Addendum # 1

Date: November 5, 2018

Project No.: 2223.000

Project Name: Children's Specialized Hospital - Hamilton Expansion and Renovation

SKA-01

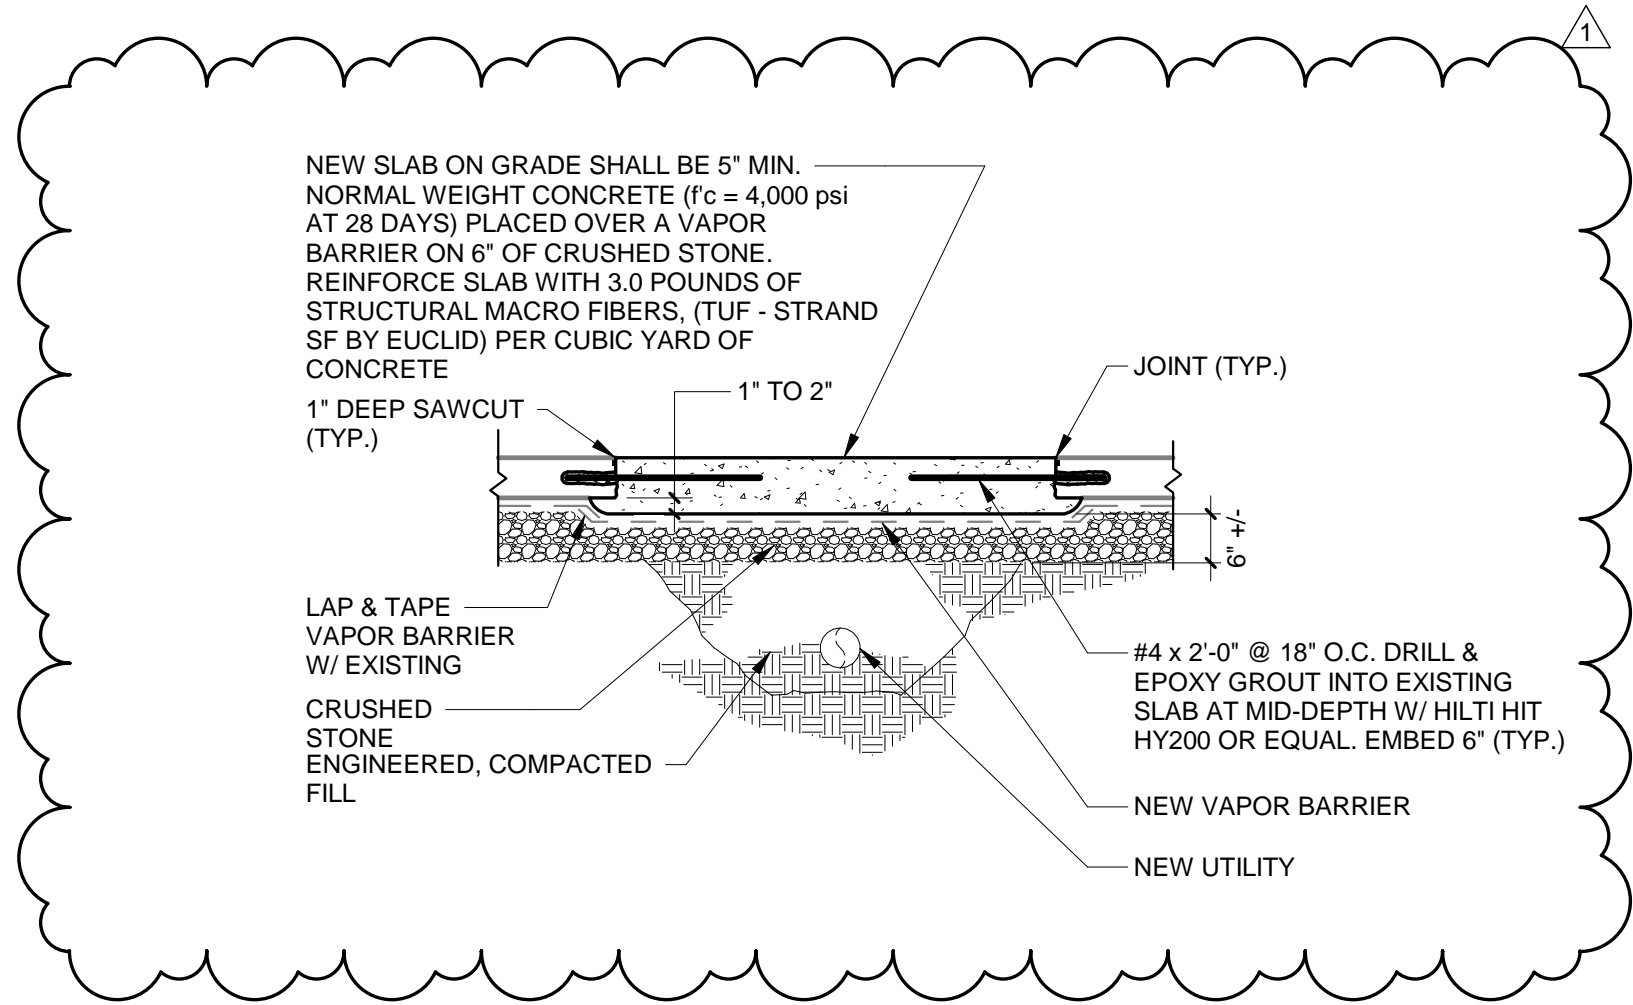
1.9 REVISE Detail 25 on Sheet A0.31 for Typical Utility Trench/Slab Infill Detail per attached revised version, as shown on Sketch SKA-01.
